**AGENDA**  
**CITY OF CREVE COEUR**  
**PLANNING AND ZONING**  
**300 NORTH NEW BALLAS RD**  
**SEPTEMBER 16, 2024**  
**6:00 PM**

- 1. Public Hearing. #24-023: An Amendment to an Existing Conditional Use Permit with Associated Site Development Plan for St. Louis Elks Lodge #9 Located at 12481 Ladue Road**

### #24-023: A NEW CONDITIONAL USE PERMIT WITH ASSOCIATED SITE DEVELOPMENT PLAN FOR THE ST. LOUIS ELKS LODGE #9 LOCATED AT 12481 LADUE ROAD

**RE: Elks Lodge #9 – Expansion Project**  
**Conditional Use Permit Amendment with Site Development Plan**  
**Application #24-024**  
**Response Letter**  
**Stock Project No. (2023-7477)**

SOLID VINYL PRIVACY FENCE DETAIL

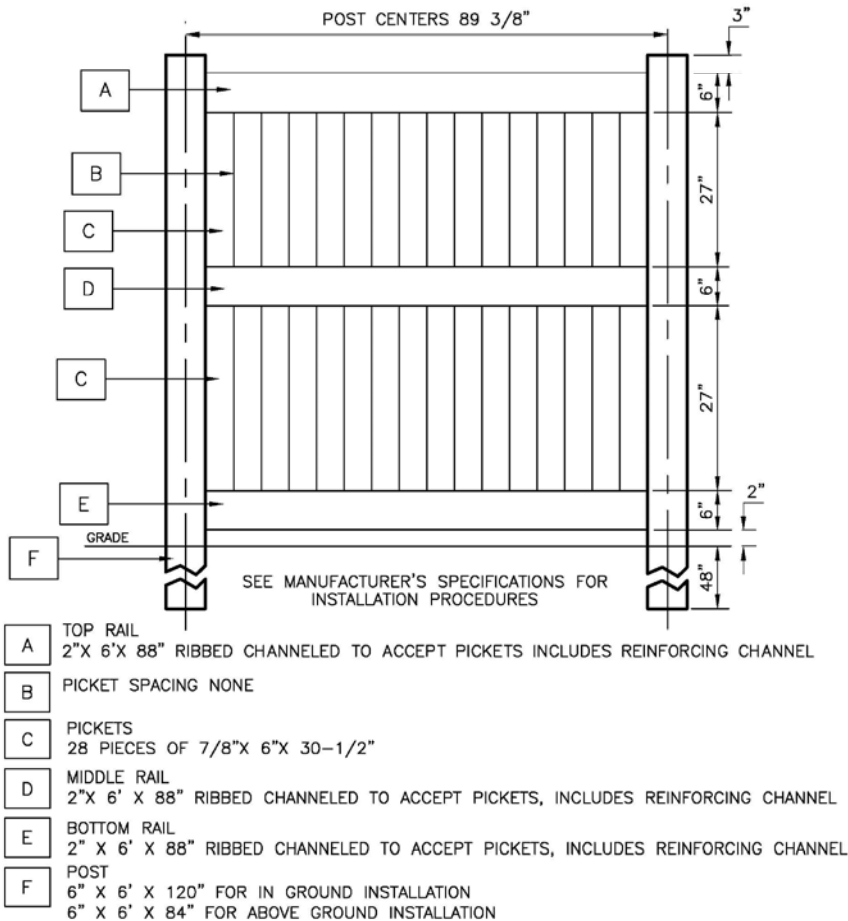
6. *Please update the fence detail to show a vinyl fence instead of a wooden fence. Color of vinyl fence should be a neutral or tan and included on the plans.*

**Response: Fence shall be a neutral or tan (approved by adjacent residential owner) vinyl fence. This was labeled on the plans accordingly.**
